Re: Framing Items
Location: Lot 345 Serenity (36 Firefly Ln. Fuquay-Varina, NC)
JDS Project No.: RDU2507319
Date of Inspection: 07/16/25

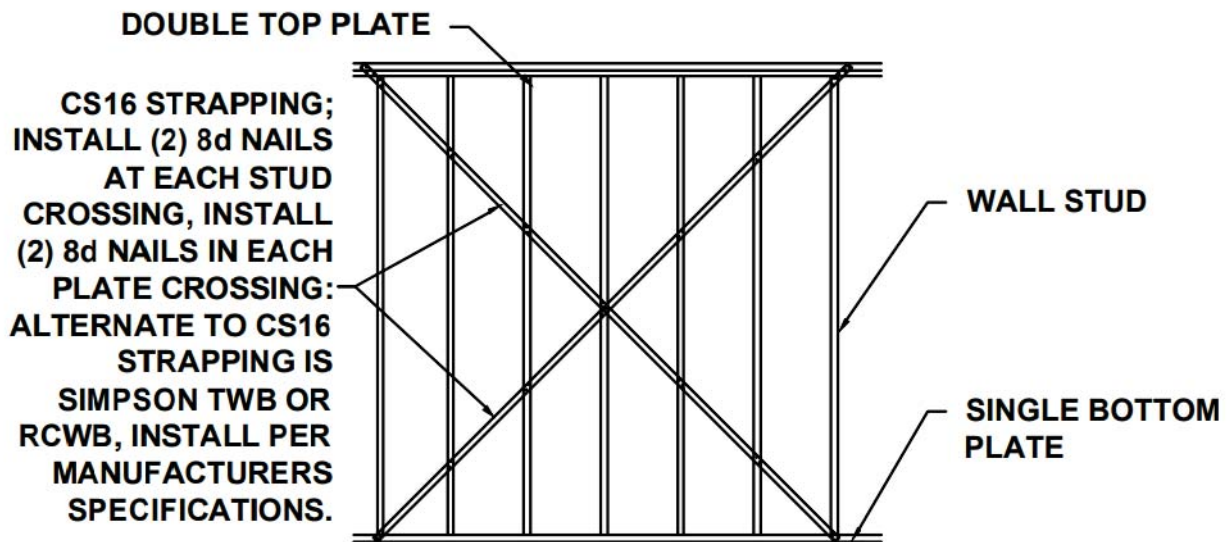
1. The 5th I-joist from the left (from the kitchen) has top flange damage on the left face at the approximate mid-span.
2. The inspector is questioning the continuous 2x6 header that spans over the windows on the 2nd floor on both sides of the house. No wall framing is specified on the plans. The builder stick build the wall framing around the windows. There are (4) king studs between the two windows and (2) kings either side of each window. The 2x6 header is a single ply, and the above gable truss at the right side of the 2nd floor is bearing atop of the top plate. The wall is a 2x4 wall.
3. The client did not install OSB as per detail 7 on page SD2.0 at the front shear wall at the right front of the 2nd floor.

1. Pack out the web by the full depth by 4' long by 3/4" thick OSB centered on the damage attached with construction adhesive and (3) rows of 10D nails spaced at 4" o.c. Then install a 4' 2x4 scab centered on the damage attached with (2) rows of 10D nails spaced at 4" o.c. with (1) row in the web and (1) row in the flange.
2. The continuous 2x6 across the gable at both sides of the house is adequate for the anticipated loading, no further repairs are required.
3. We recommend installing Cross Braced LIB bracing on the backside of the wall for the length of the designed shear wall. Install CS16 strapping along the wall per the detail noted in the following page.
